Subject: Duke Energy Carolinas, LLC  
William States Lee III Nuclear Station - Docket Nos. 52-018 and 52-019  
AP1000 Combined License Application for the  
William States Lee III Nuclear Station Units 1 and 2  
Response to Request for Additional Information  
Ltr# WLG2008.10-13

Reference: Letter from J.M. Muir (NRC) to B.J. Dolan (Duke Energy), *Request for Additional Information Regarding the Environmental Review of the Combined License Application for William States Lee III Nuclear Station Units 1 and 2*, dated August 21, 2008

**Lee Nuclear Station Response to Request for Additional Information (RAI)**

# **Monthly Precipitation Greenville-Spartanburg Area**

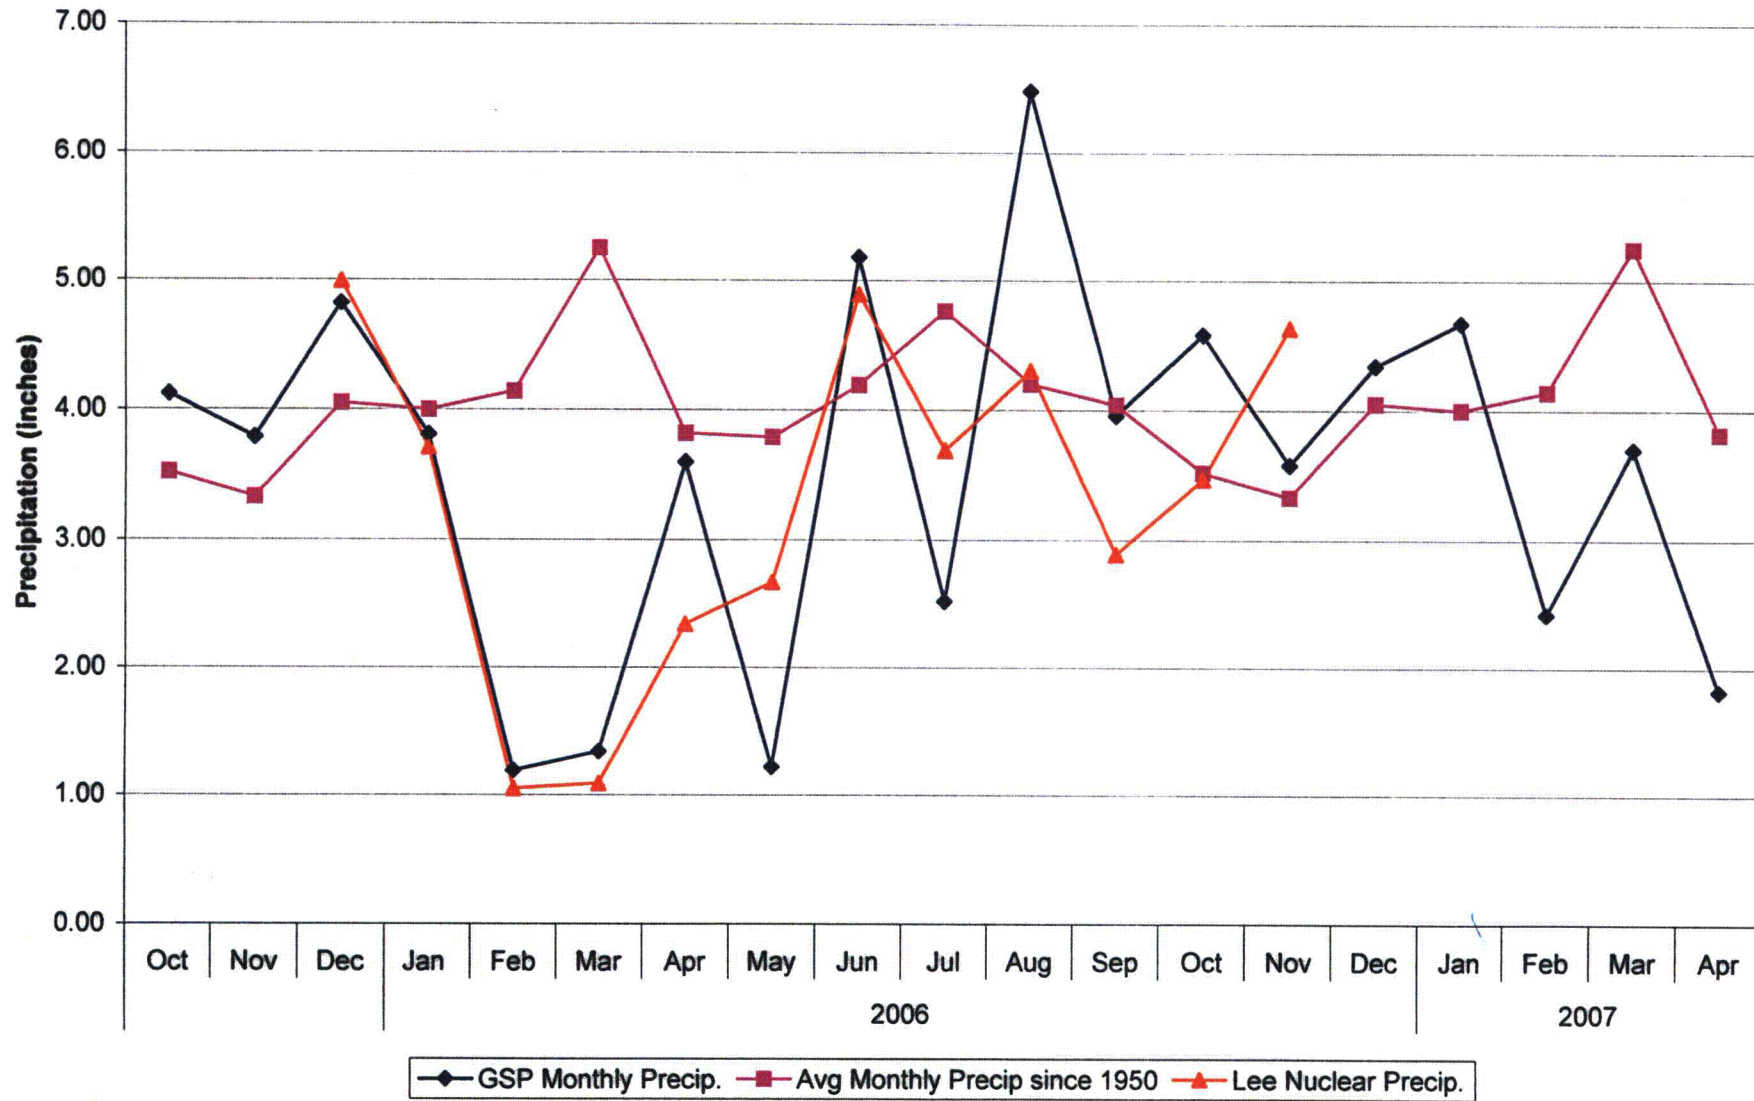
Submit monthly precipitation amounts for the period October 2005 through April 2007 which predates and corresponds with the water table data in Figure 2.3-15. Submit an explanation for the relationship between precipitation received during this period, groundwater levels, and normal monthly amounts of precipitation.

Additionally, using the GSP precipitation data from 1950 to 2008, average monthly values were calculated (Attachment 9-1, Page 1) to determine "normal" monthly precipitation to evaluate whether the observed average monthly precipitation at the Lee Nuclear Site was relatively wet or dry during the investigation; "normal" in the remainder of this response refers to those average monthly values. The graph presented on Attachment 9-1, Page 3, shows the monthly precipitation data observed at the Lee Nuclear Site and GSP. It also shows the normal average monthly data described above. From October 2005 to January 2006, above normal precipitation occurred at the Lee Nuclear Site. From January 2006 to around October 2006, Lee Nuclear Site conditions were typically drier than normal. November 2006 was wetter than normal. From December 2006 through April 2007, the Lee Nuclear Site had around normal to below normal precipitation amounts.

**K vs. Depth Analyses for Cherokee and Lee Investigations**

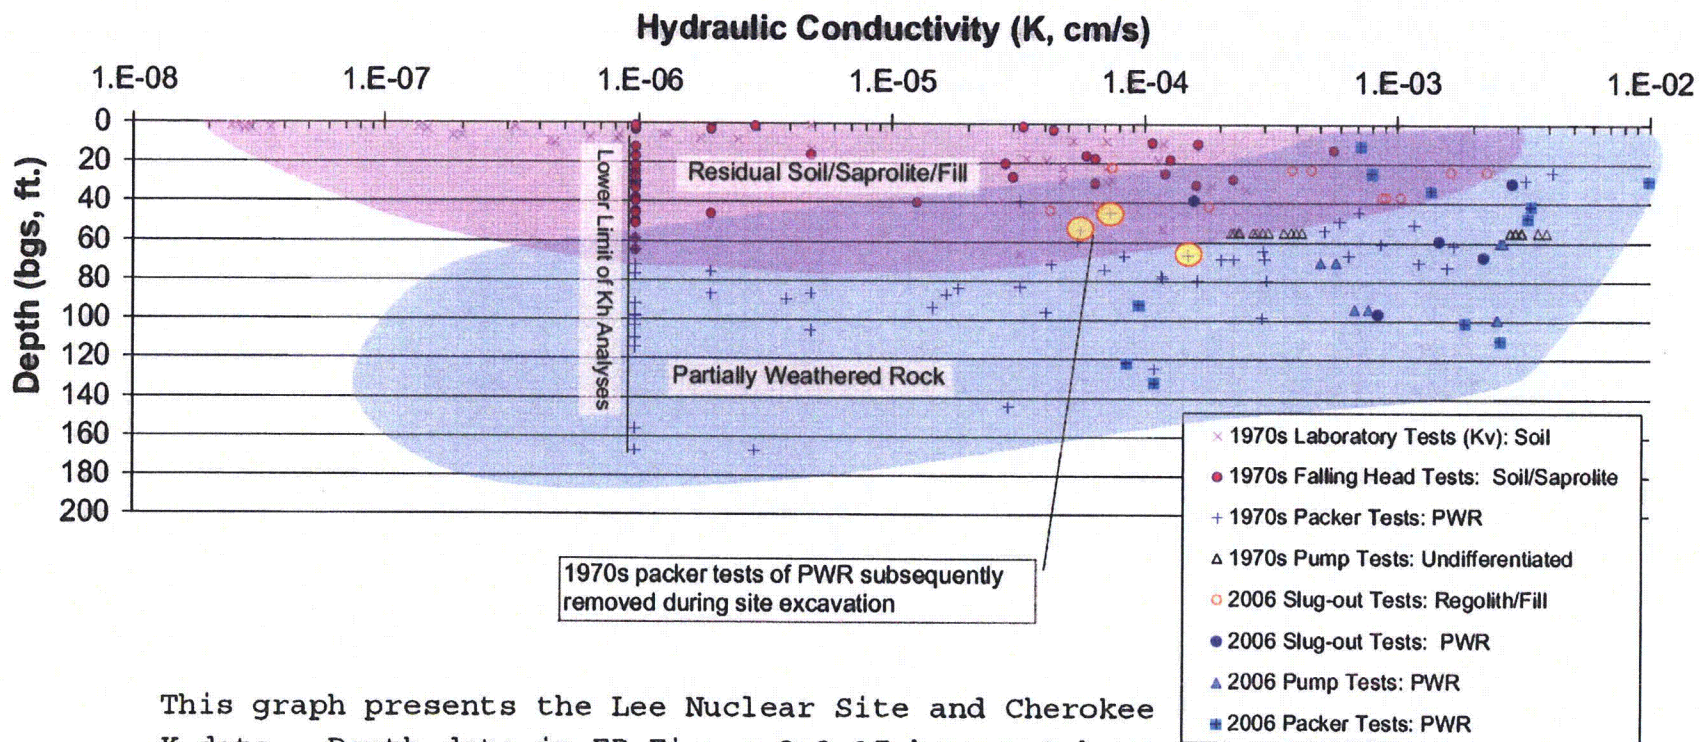
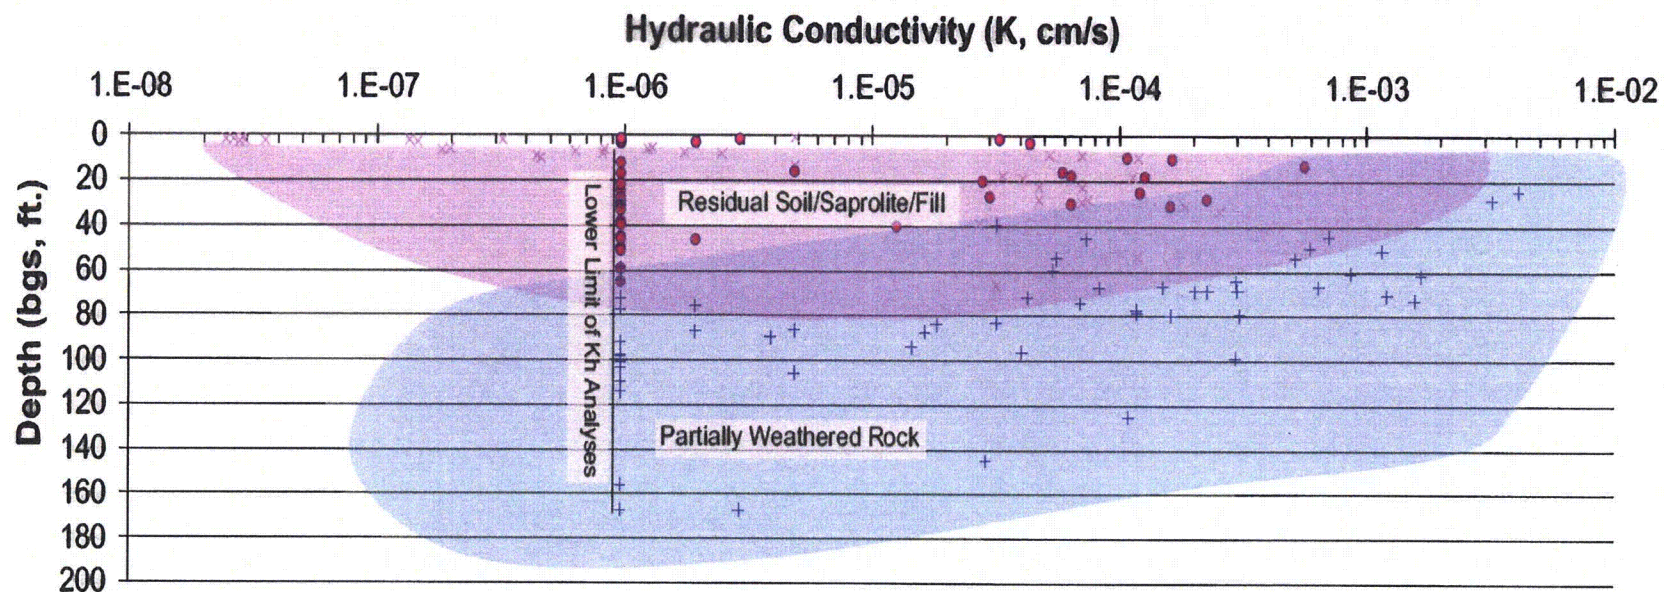
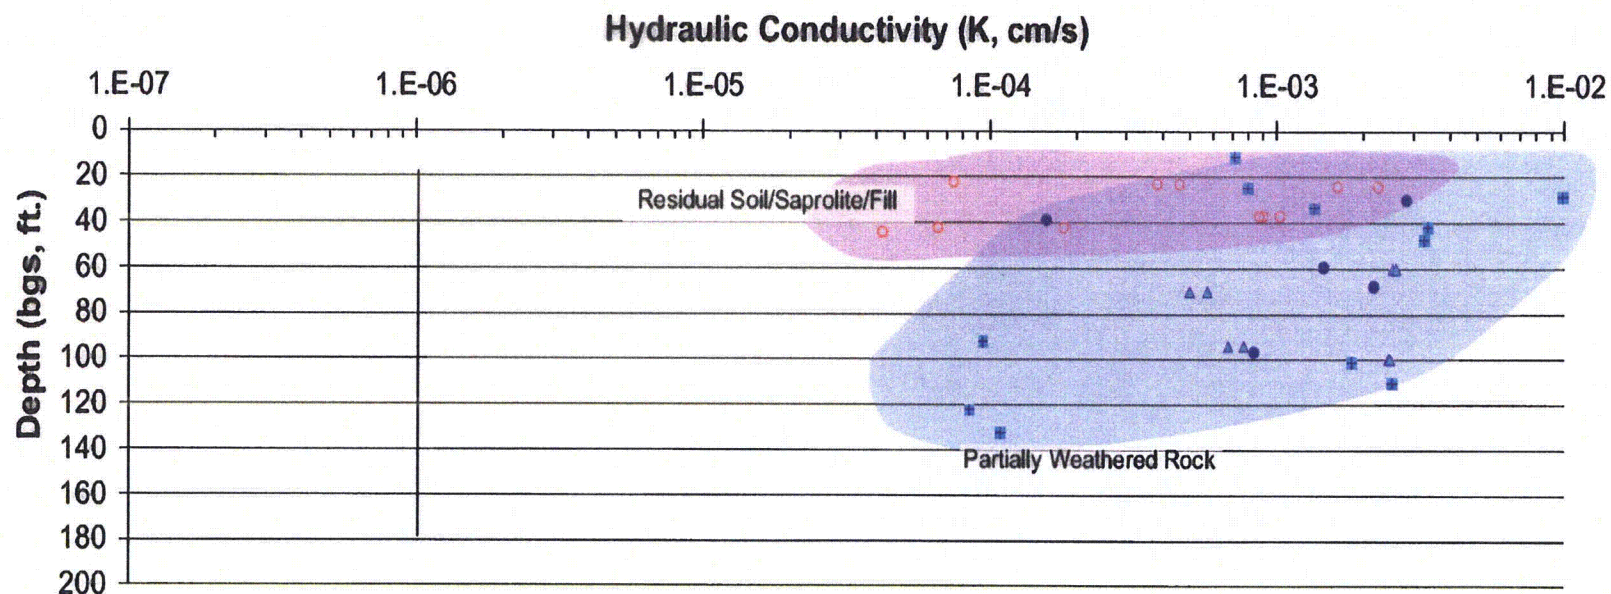
Submit a description of how the depth data in Figure 2.3 - 17 have been adjusted or rectified to reflect the correct elevation for the hydraulic conductivity data points. Include an explanation of how the depth differences add "noise" and "bias" to the K versus depth comparison.

Depth data in Figure 2.3-17 have not been modified to adjust for changes between pre-Cherokee construction era elevations and the current elevations, but it is recognized that the 2006 data and 1970s data do not share a constant datum (i.e., 1970s surface grade elevations do not equal the 2006 surface grade elevations). The 2006 hydraulic conductivity (K) data verify the typical ranges of 1970s K values relative to lithology [e.g., K values determined in 2006 for partially weathered rock (PWR) were generally consistent with PWR K values determined in the 1970s]. While the depths of the samples collected in areas of cut and fill have changed, the soil and rock characteristics have not. Therefore, the depth changes add "noise" to Figure 2.3-17. Attachment10-1 provides graphs to evaluate the 1970s K data and 2006 K data separately. Separating the data sets allowed independent comparisons of K versus depth.

This graph presents the Lee Nuclear Site and Cherokee K data. Depth data in ER Figure 2.3-17 have not been modified to adjust for changes between pre-Cherokee construction era depths and the current depths. Similarly, a 2006 fill area sample would yield an apparently deeper K value than a 1970s sample. The 2006 data were collected to verify the findings of the Cherokee investigation, and both data sets support the apparent decrease in K with increasing depth for partially weathered rock (see Pages 2 and 3 of RAI-10-1). Depth is measured in feet below ground surface (bgs).
